CS Memorandum No. 1346

To: Distribution
From: Susan MacKenzie, Document Control Manager 
Date: January 30, 2013
Reference: Project No. M544.1, Contract No. CS-149
Task No. 1-8.02, Change Control
Subject: Configuration Management Board Meeting No. 111

CMB Meeting Minutes #111

SUBJECT: Configuration Management Board Meeting # 111 – Rev. No. 0

Sta. 164+97, Panel P-12

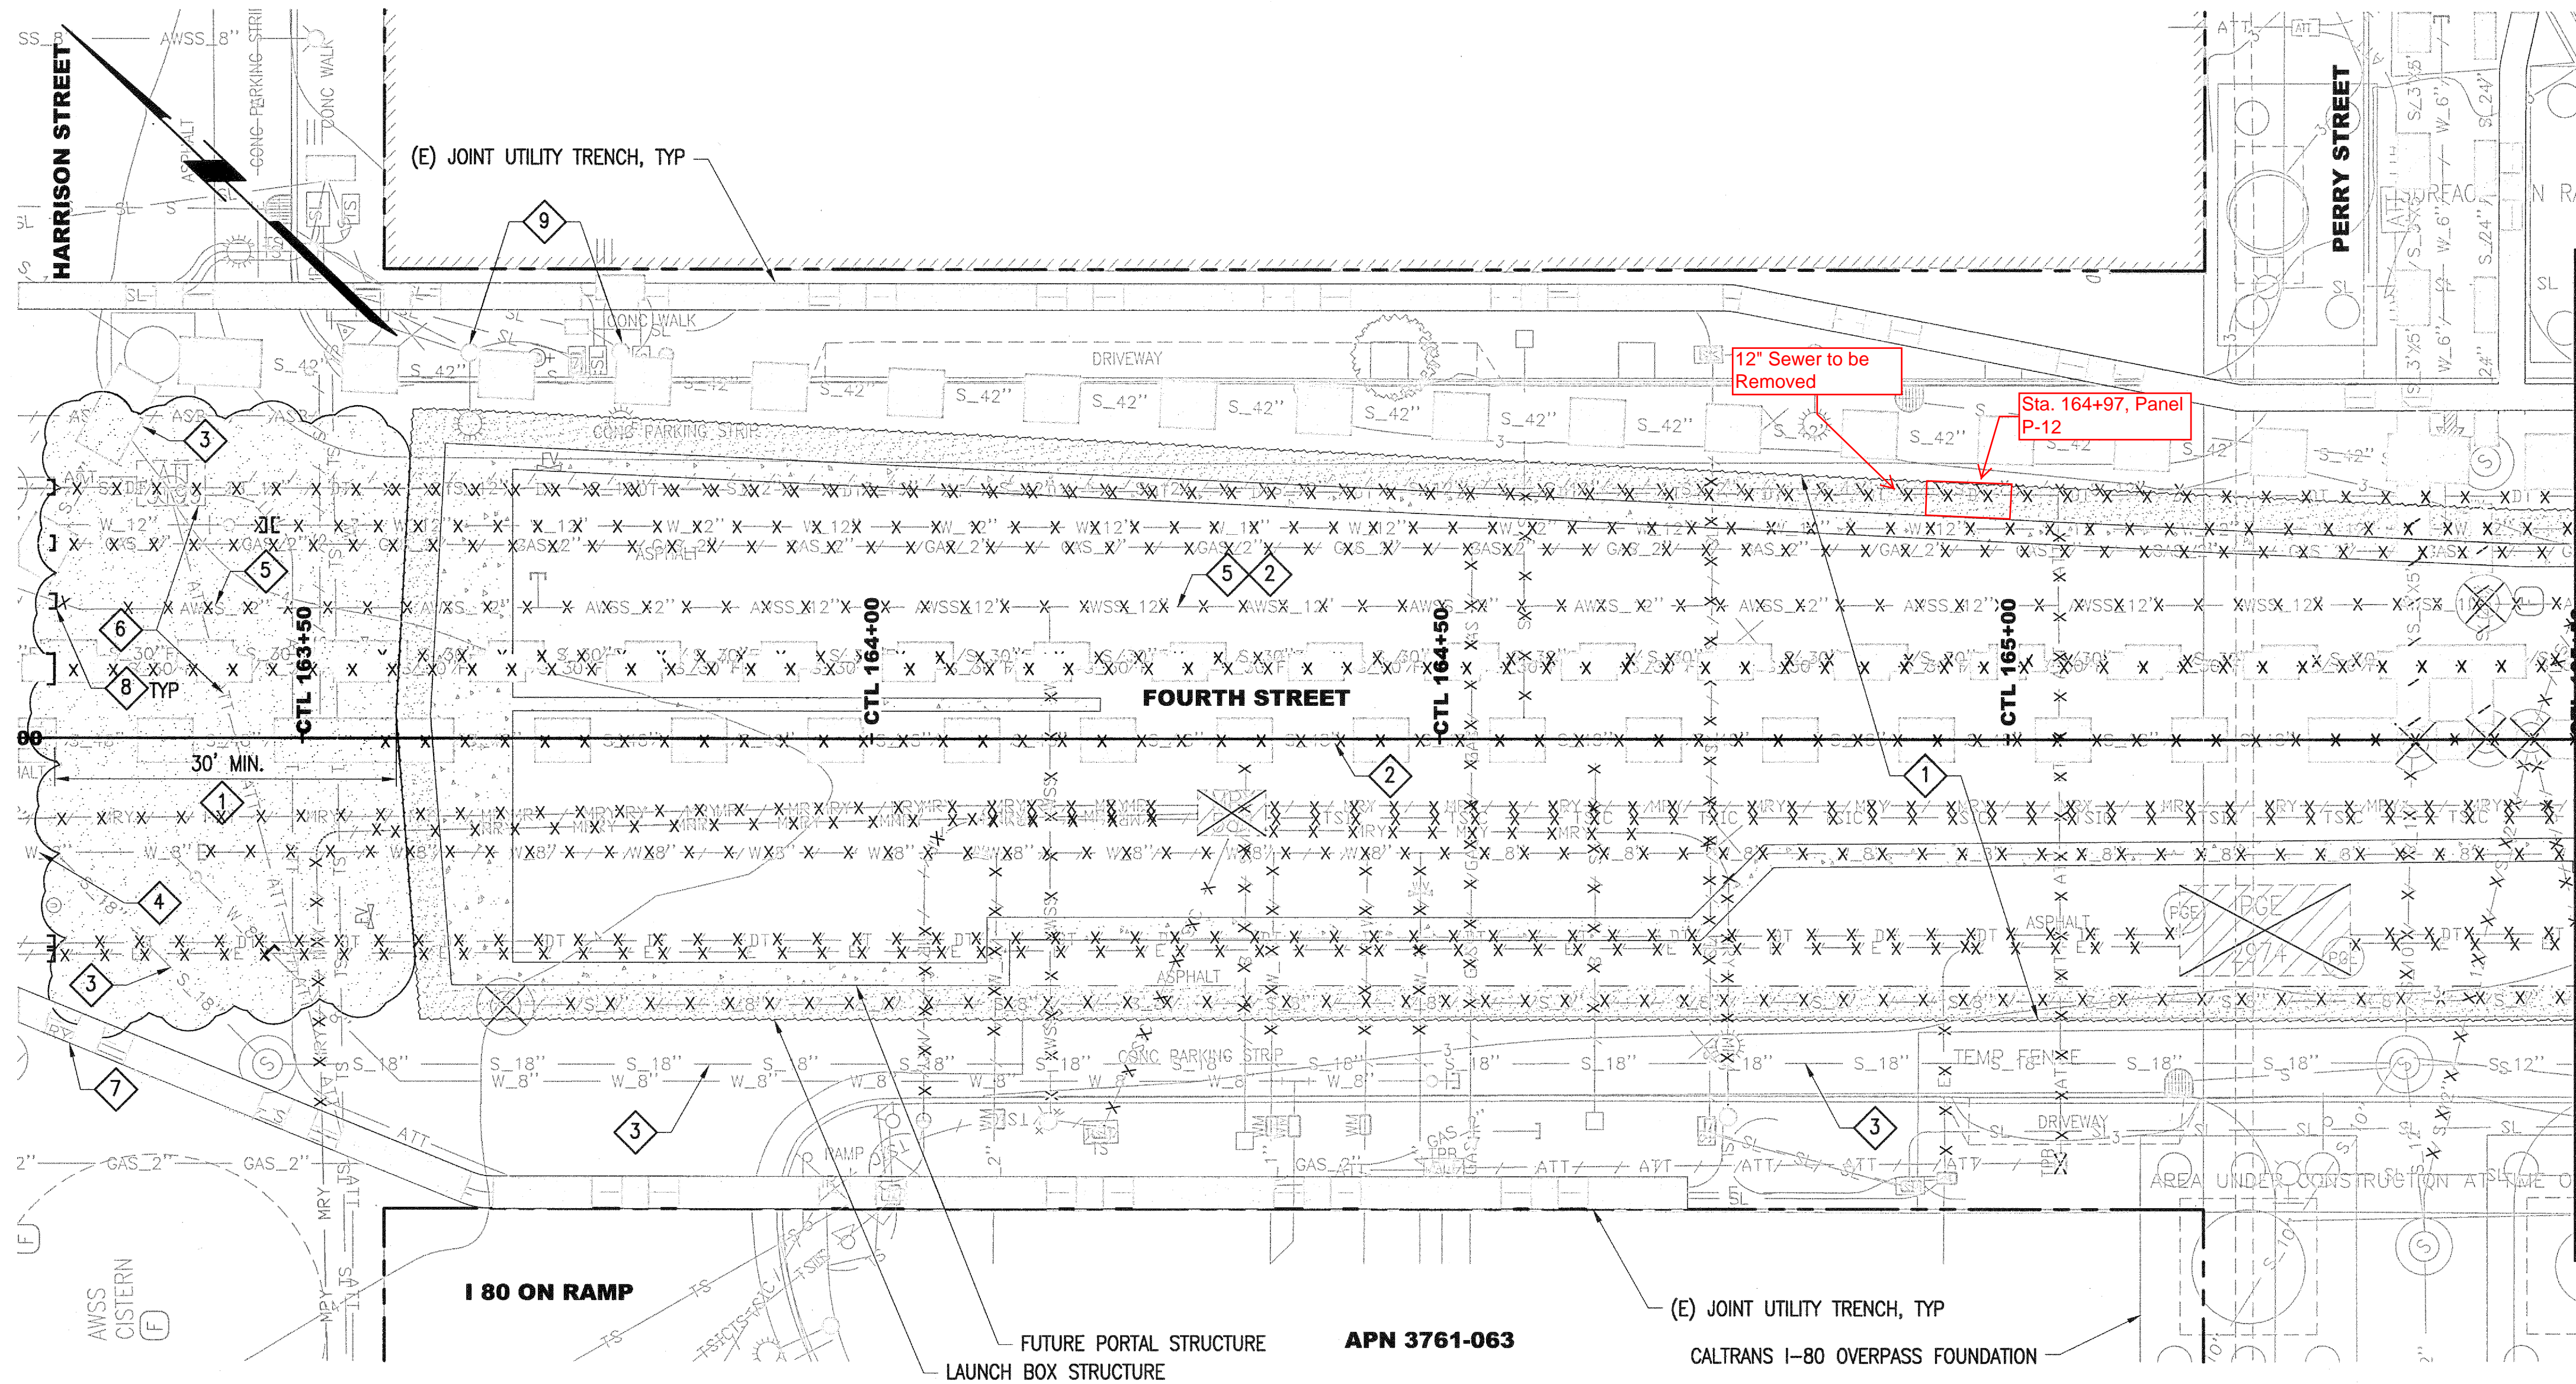
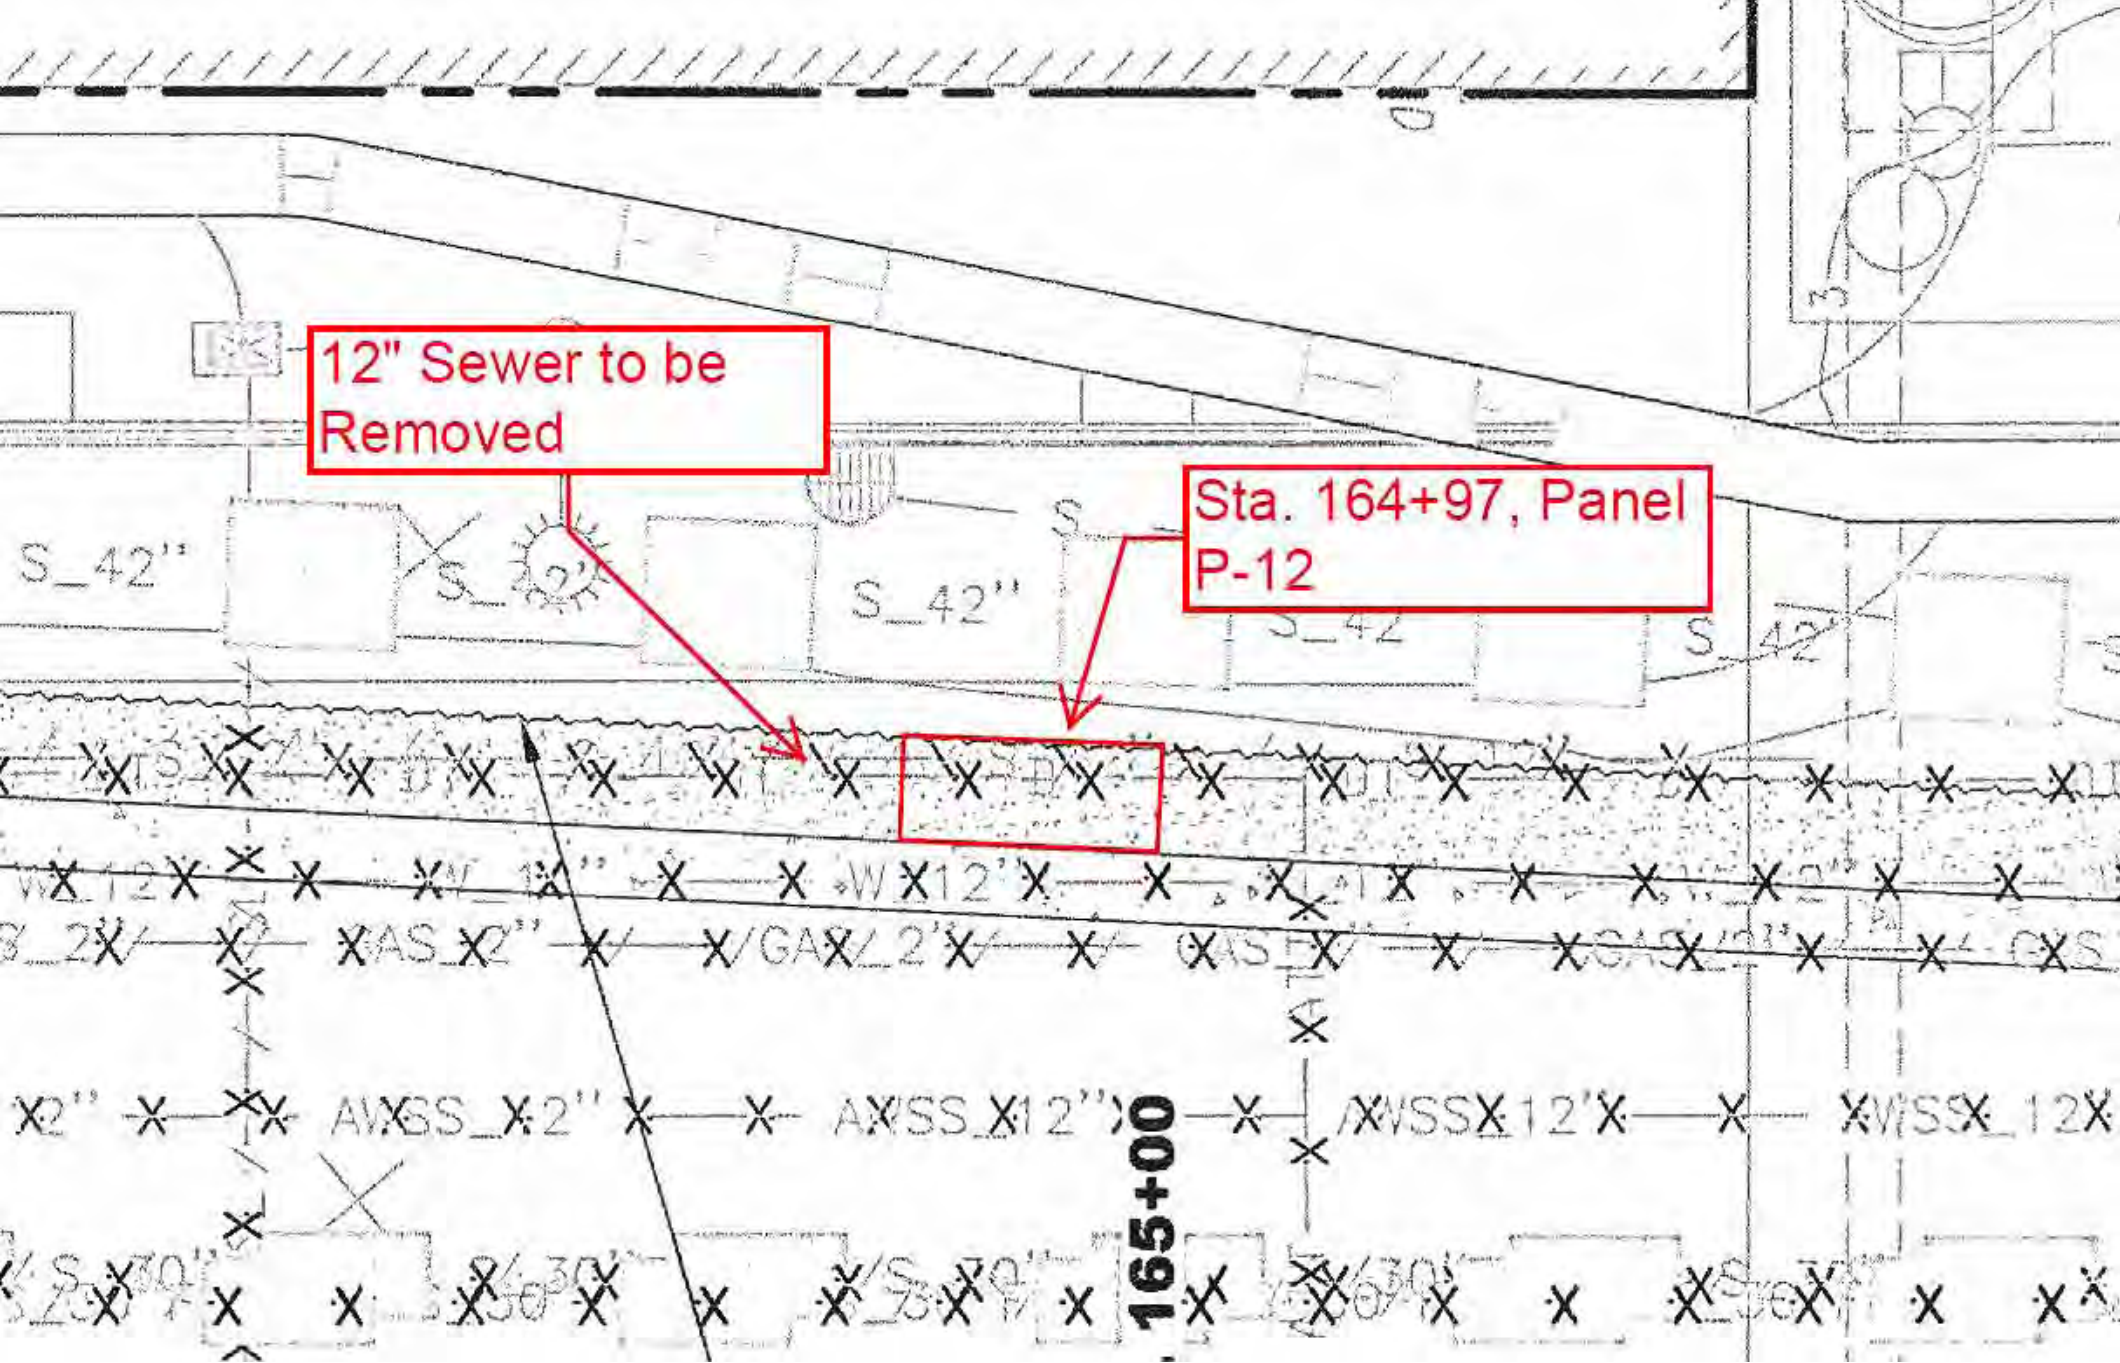
Facts: On November 13th 2012, the Contractor encountered concrete encasement around a 12 inch clay sewer pipe within Slurry Wall (SW) panel P-12 at the TBM Launch Box approximately 7 feet below the top of the SW guidewall. The concrete encasement caused the SW to deviate from the designed excavation limits. To correct the verticality of the panel excavation, the panel was backfilled with lean concrete and re-excavated as agreed upon by the RE.

This change affects a critical path activity. SFMTA inspectors documented an impact of approximately 3 days to SW P-12. We have asked the Contractor to combine the TIA for CORs 62, 65, and 67 and we have not yet received the TIA.

Justification: Drawing UD-502, Rev. 0 does not indicate the presence of the concrete encasement within the footprint of SW panel P-12. The concrete encasement prevented SW construction from occurring as originally planned. RE has evaluated the conditions outlined in Article 3.04 and found that: conditions differ materially and conditions caused the scope of work to increase.

CONTRACT NO. 1252	
SFMTA CONTROL NO. CL-18032	
DRAWING NO. UD-502	REVISION 0
SHEET NO. 85

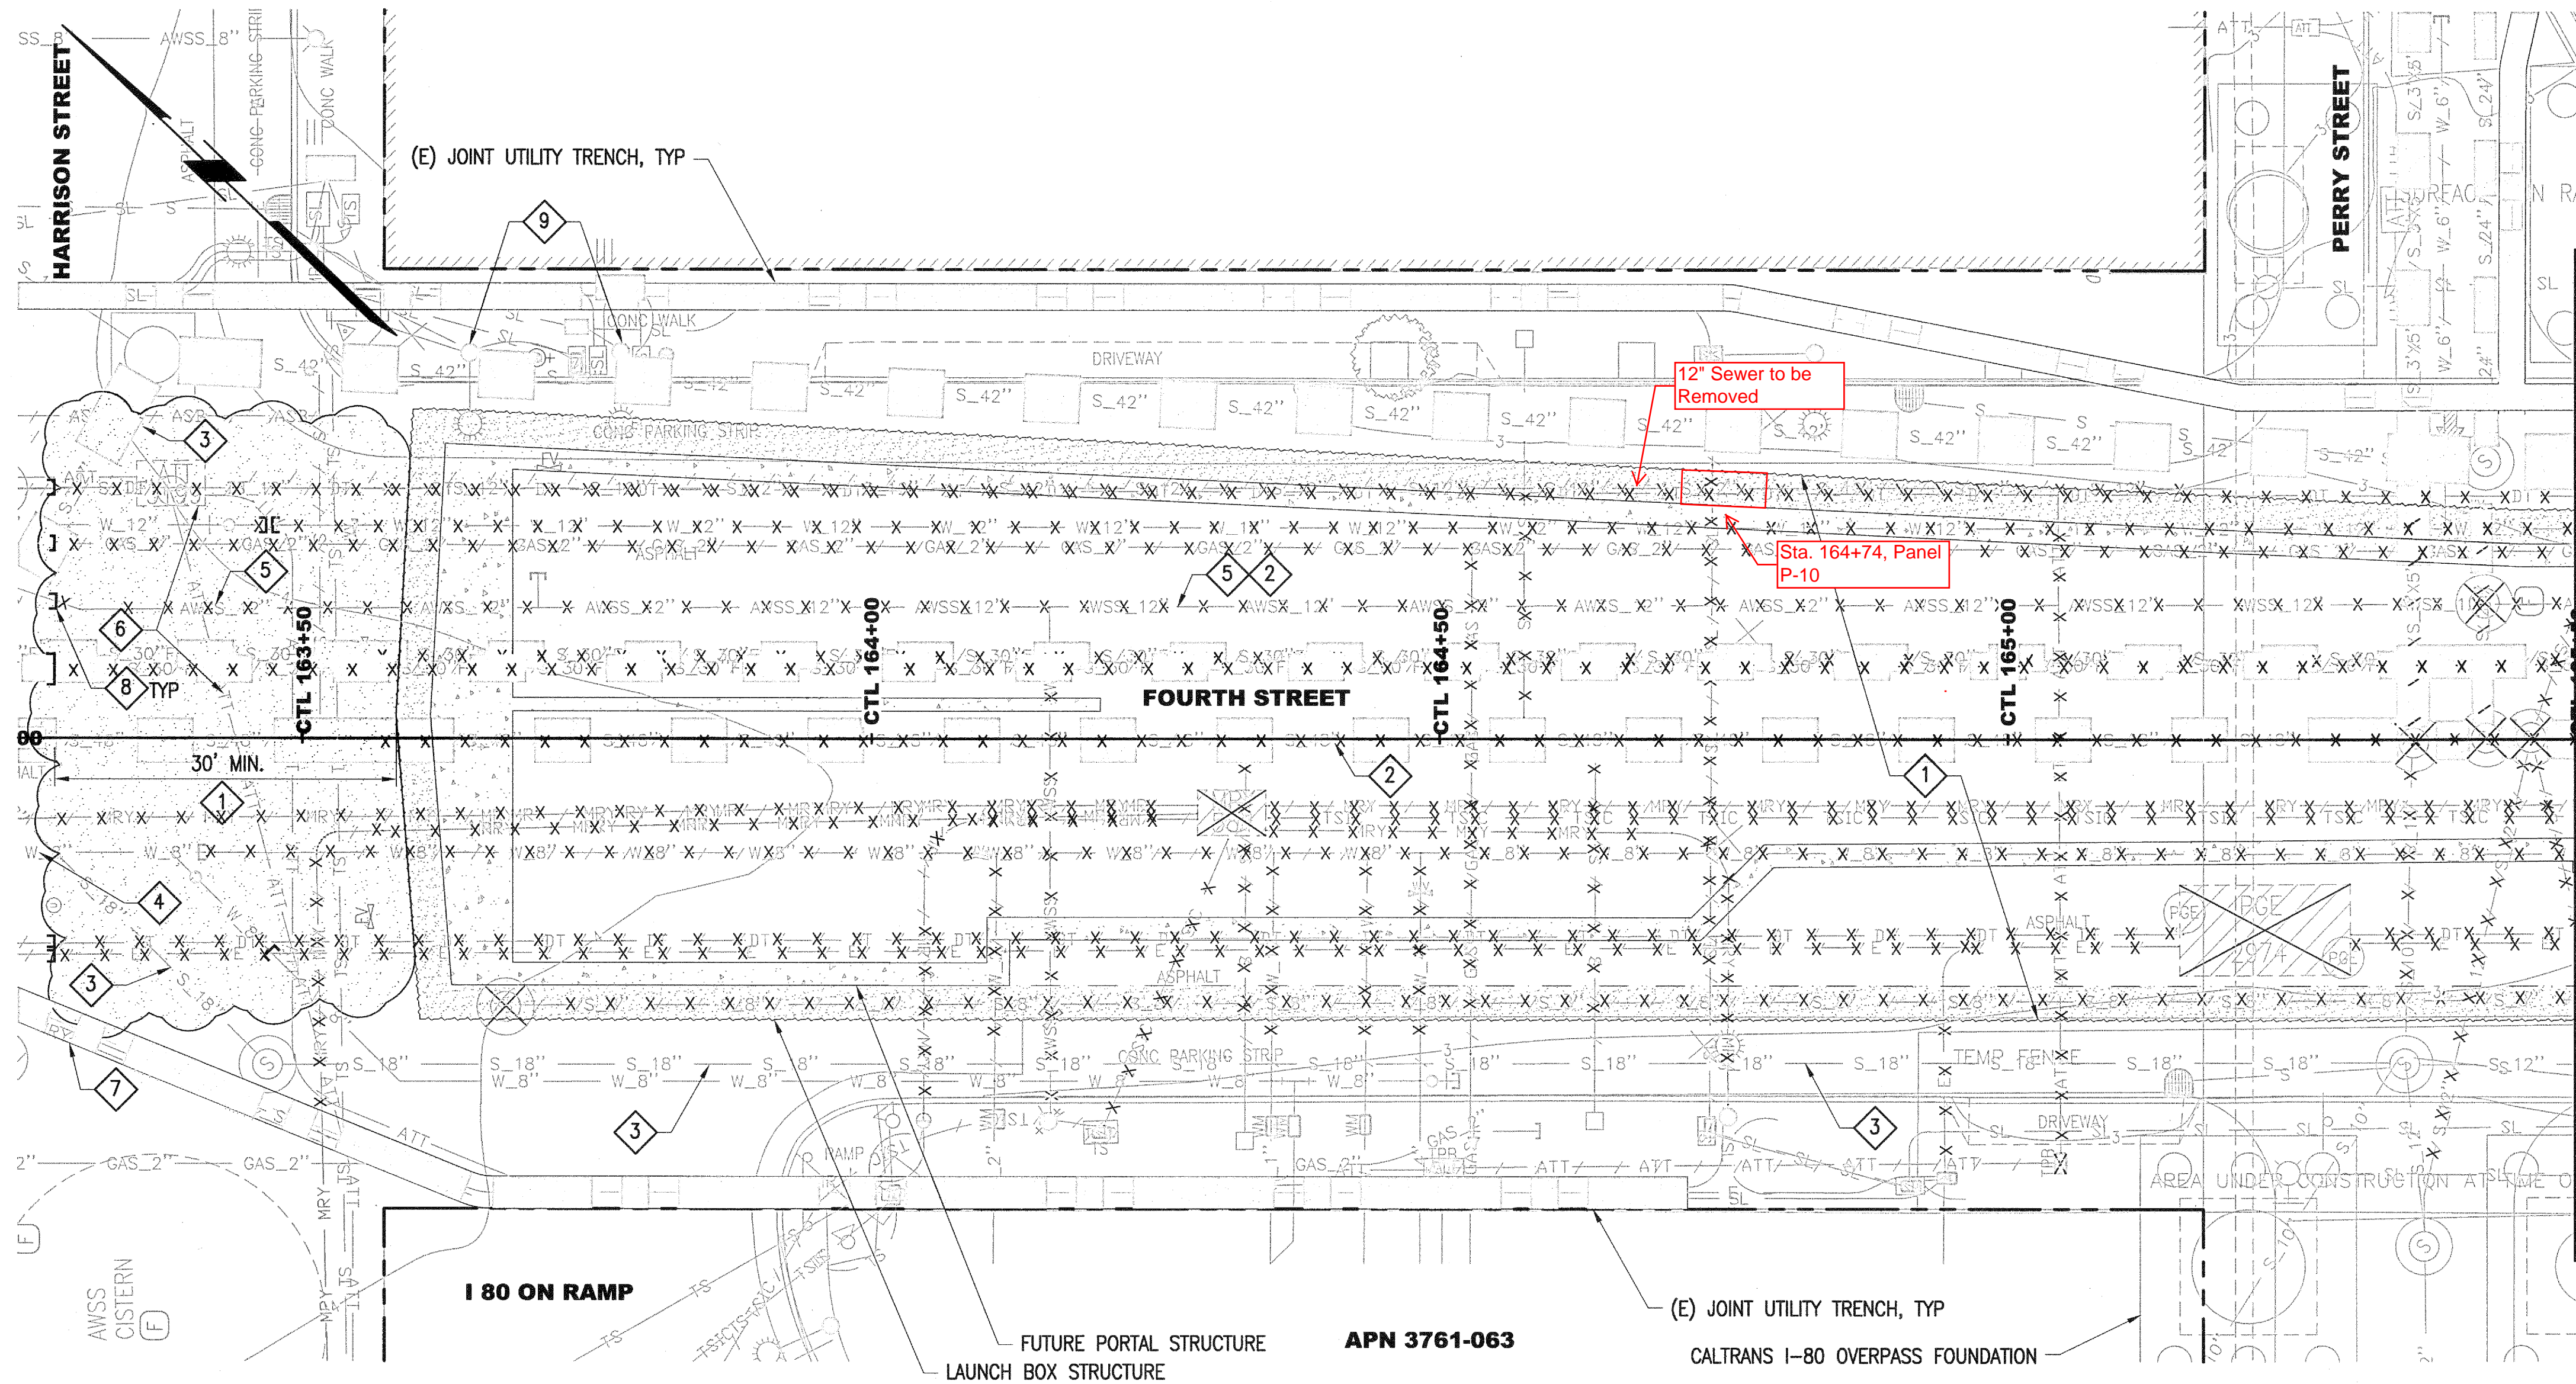
Facts: On November 19th 2012, the Contractor encountered concrete encasement around a 12 inch clay sewer pipe within Slurry Wall (SW) panel P-10 at the TBM Launch Box approximately 7 feet below the top of the SW guidewall. An excavator was used to clear the obstruction. This change affects a critical path activity. SFMTA inspectors documented an impact of approximately 4 hours to SW P-10. We have asked the Contractor to combine the TIA for CORs 62, 65, and 67 and we have not yet received the TIA.

Justification: Drawing UD-502, Rev. 0 does not indicate the presence of the concrete encasement within the footprint of SW panel P-10. The concrete encasement prevented SW construction from occurring as originally planned. RE has evaluated the conditions outlined in Article 3.04 and found that: conditions differ materially and conditions caused the scope of work to increase.
